SERVICE BULLETIN

RIB SUPPORT MODIFICATION FOR FIBER GLASS STABILIZER -
ELEVATOR TIP.

SB-Ibis-006

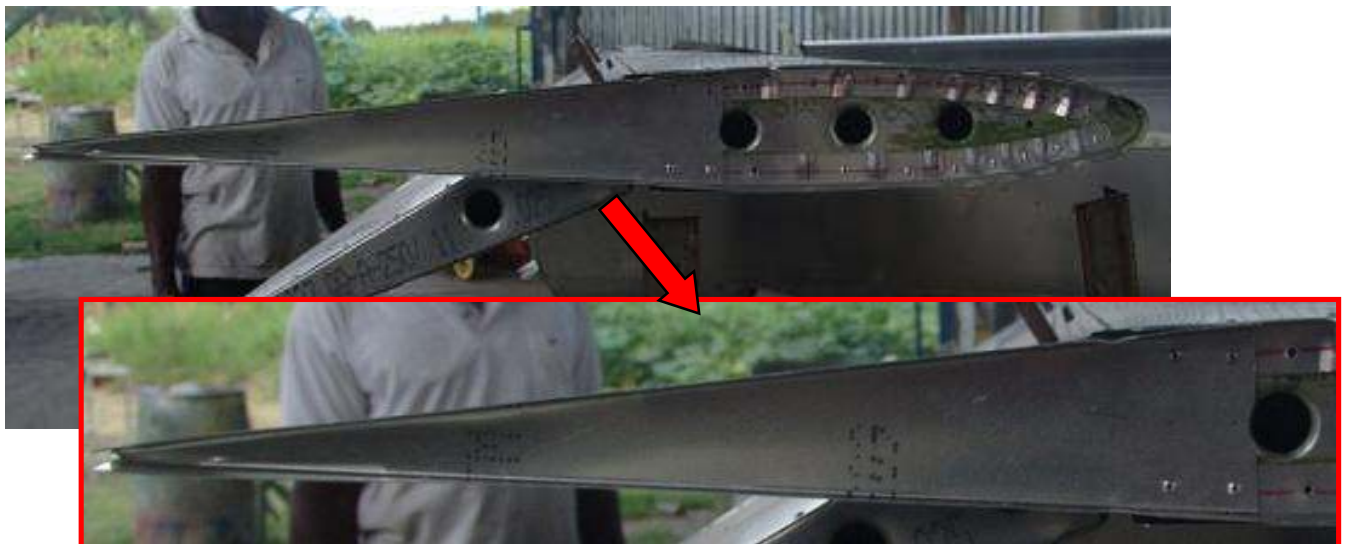
1. It was detected that a great pressure on the stabilizer-elevator fiber tip that tended to warp it, and with excessive force could crack and eventually to fall of. Due to the flexibility of the fiber this process could only occur if no preventive check ups are performed before each flight which each pilot should do before boarding the aircraft, besides the fiber tip should not be subjected to greater pressure undertaken by a person.

Modify the support of the fiber glass stabilizer-elevator rib tip.

INSTRUCTION. When applying pressure on the fiber tip, this deforms, therefore the tie should be strengthened, completing the rib that is located inside the fiber holding the stabilizer.

A new rib must be made to replace the internal fiber rib stabilizer- elevator tip, this rib new rib is in 0,025 Dural strip, and it joins the stabilizer making sure to leave a considerable space, between the fiber tip and the stabilizer-elevator and the movement of the elevator, there should be no friction.

Completed the new rib and positioned, proceed to rivet the stabilizer- elevator fiberglass tip, to the airframe.
